# 3 Presentation of officer reports

# 3.1 49 Peate Avenue, Glen Iris

Application no.: PP19/0706.01
Responsible director: Scott Walker
Authorised by: David Cowan

# STATUTORY PLANNING OFFICERS REPORT Urban Planning Committee

Above: Proposed Ground Floor Plan, previously approved outline of ground floor in blue

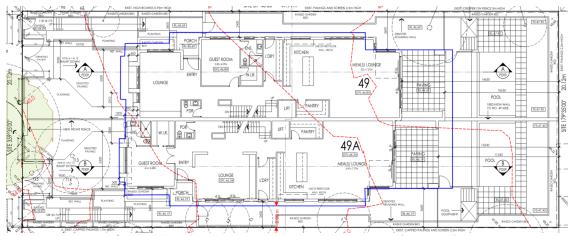
It is proposed to modify the ground floor as follows:

- Increase the side setbacks by a minimum 0.4 metres (each dwelling).
- Increase the rear setbacks by 5.29 metres (No. 49A) and 4.72 metres (No. 49).
- Increase front setback of No. 49 by a minimum 1 metre.
- · Addition of pools to rear of each dwelling.

Above: Proposed First Floor Plan, previously approved outline of first floor highlighted in blue

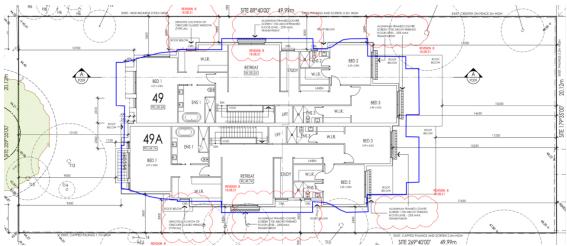
It is proposed to modify the ground floor as follows:

# **Elevation Plans:**

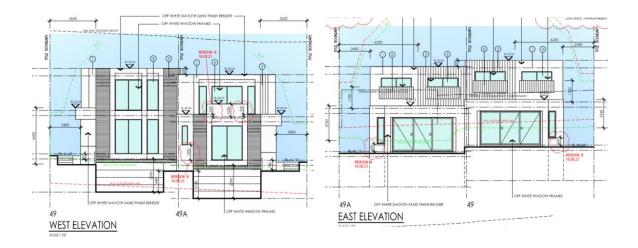
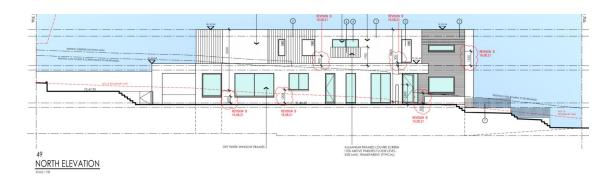
It is proposed to modify the elevations as follows:

- Front façade design modified by deletion of curved features and parapets.
- Addition of new materials (brick and standing seam cladding) to all elevations
- Addition of balcony to No. 49A.
- Modification of location of windows and type of screening.
- Overall height of both dwellings lowered.

### Re-arrangement of driveway alignment, modify driveway landscaping

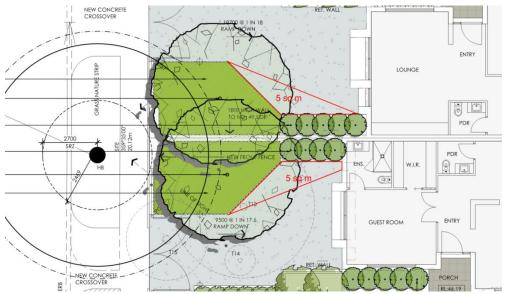
It is proposed to re-align the driveway of each dwelling, and introduce additional hard paving within the front setback. This results in lost opportunities for soft landscaping on within the front setback of the dwellings and reduced areas for the vegetation within the front setback to grow.

A condition is recommended for the development to provide an additional 5 square metres of soft landscaping to each dwelling, to the southern portion of the driveway associated with No. 49 and to the northern portion of the driveway associated with No. 49A. An example is below:

Above: Previously advertised landscape plan (PP19/0706)

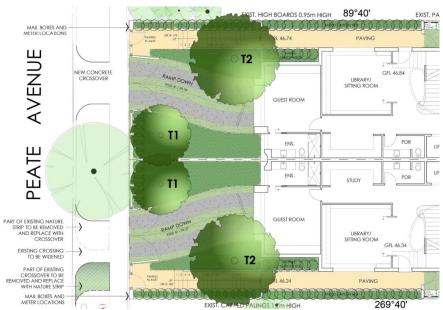
It is also noted that the driveway has been modified by removing the Mondo Grass on the two accessways. The previously advertised landscape plan showed:

As the previously approved Mondo grass provided an improved outlook from the street, reducing the appearance of the hard surfacing within the front setback, and softening the appearance of the basements, a condition is recommended to reinstate the Mondo Grass along the accessways of each dwelling. The Mondo grass should be located either in the centre or sides of the accessways to provide meaningful softening of the hard surfacing.

# Front setback of Dwelling 1 increased

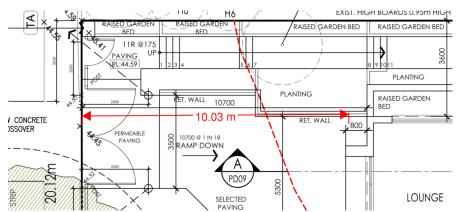
Condition 1 a) iii. of the permit required the front setback of No. 49 (guest bedroom) to be increased by 1 metre to the windows, and 500mm to the wall.

#### Rear setbacks increased to 14.6 metres and 15.2 metres

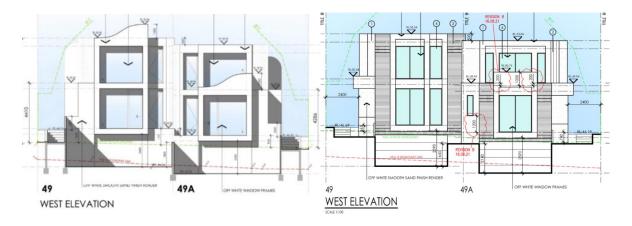
The amended design of the building footprint includes an increase to the rear setbacks by 5.29m (No. 49A) and 4.72m (No. 49). This increase in setbacks result in 14.6 metre setback for No. 49 and 15.23 metres for No. 49A. Condition 1 e) of the permit required the ground floor eastern wall of each dwelling setback a minimum 12 metres. The proposed setbacks far exceed this requirement, allowing for open backyard character to each dwelling, and providing ample landscaping opportunities within the rear setbacks. The additional setbacks to the rear improves the appearance of the dwelling from neighbouring dwellings to the north, south and east by reducing visual bulk and mass to these properties. The additional setbacks do not compromise the internal amenity of the dwellings.

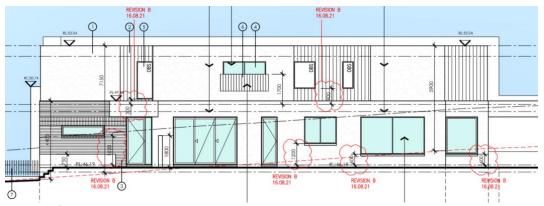
This resulted in a bland outlook to the street and to neighbouring dwellings with limited articulation.

As such, Condition 1 a) i. of the approved permit required additional external finish introduced to the façade to provide visual interest. It noted the finish must be a high-quality brick or tile. The proposed amended design proposes face brick "Daniel Robertson" in London Black. This is considered an acceptable "high-quality" material which will reflect the brick dwellings along Peate Avenue.

#### Addition of pools

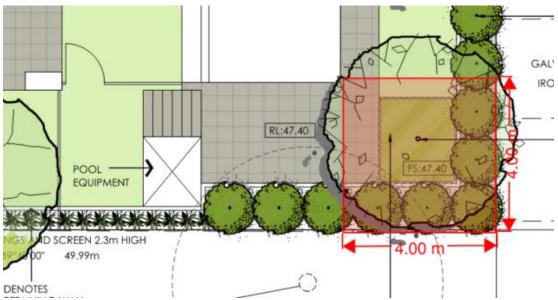
The addition of the pools within the rear setbacks of the dwellings are proposed, with space available within the backyard areas due to the additional setbacks provided for the built form. The size and location of the pools are acceptable, however there is a large amount of hard paving proposed surrounding the pools. This restricts the growth of the canopy trees within the rear setback, and reduces soft landscaping opportunities on the sites. A condition is recommended to reduce the extent of paving to allow for a minimum 4m x 4m area for each tree at the north-eastern (No. 49) and south-eastern (No. 49A) corners.
